SAFETY EVALUATION BY THE OFFICE OF NUCLEAR REACTOR REGULATION

SUPPORTING AMENDMENT NO. 11 TO FACILITY OPERATING

MONTICELLO NUCLEAR GENERATING PLANT

DOCKET NO. 50-263

FIGURE 1

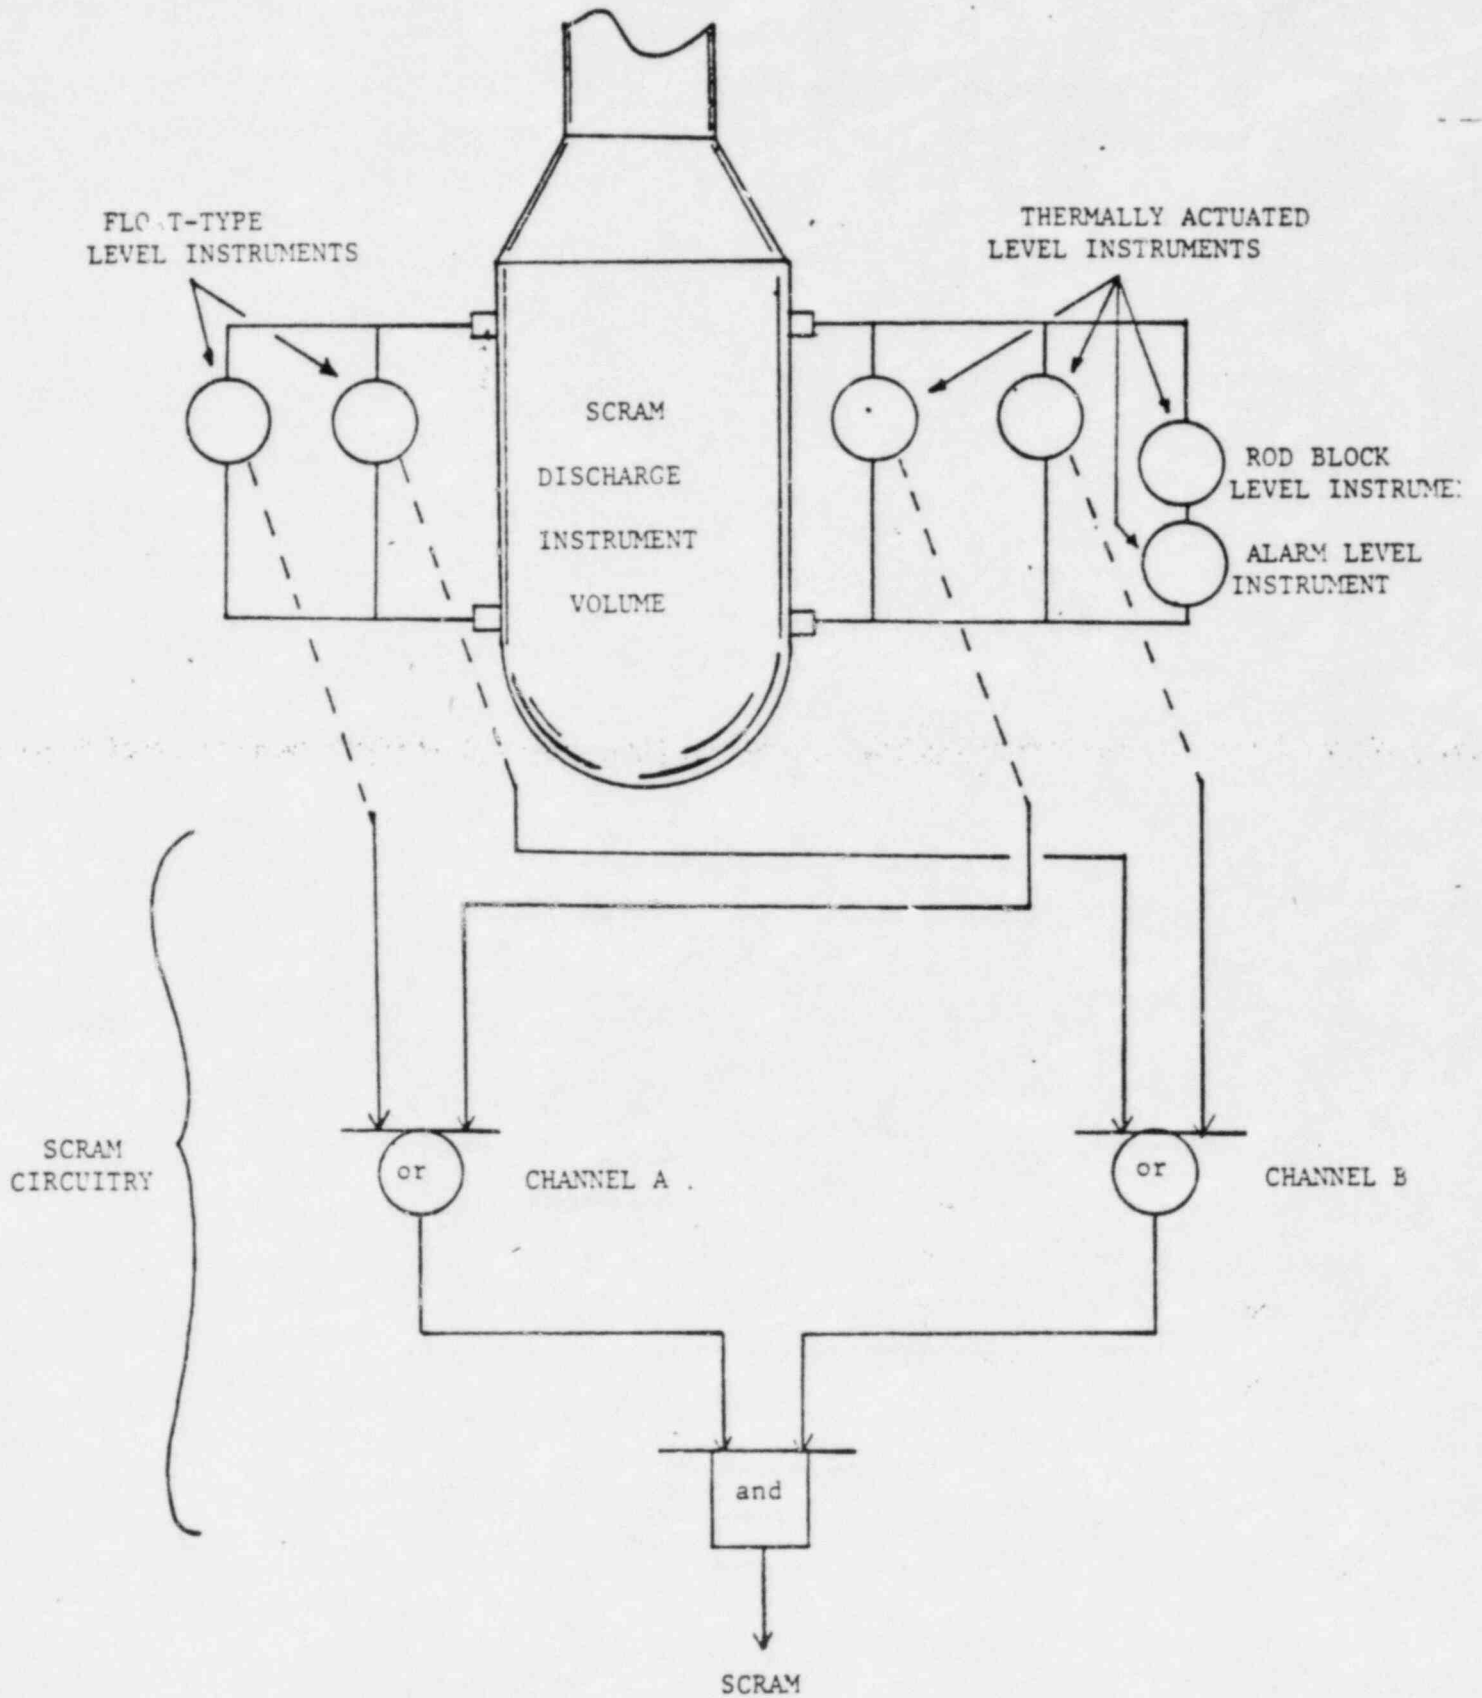
Each instrumented volume has two sets of instrument taps, providing two parallel hydraulic circuits. Scram level instruments in both hydraulic circuits assure that failure of a single instrument, or plugging of one instrument line will not prevent scram initiation. (See Figure 1.)

An acceptable means of meeting this criterion is to satisfy the requirements under Safety Criterion 3 and to install the instrumentation in such a manner that no credible active or passive failure can significantly impact the ability of the instrumentation to monitor the SDV for the presence or accumulation of water.

The licensee has satisfied the requirements of Safety Criterion 3. Scram level instruments will be installed such that no credible active or passive failure can significantly affect its ability to detect water. Since each instrument volume has two sets of instrument taps, parallel hydraulic circuits exist and therefore plugging of one line or failure of a single instrument will not prevent scram initiation. Therefore, we conclude that the licensee meets the requirements of this criterion.
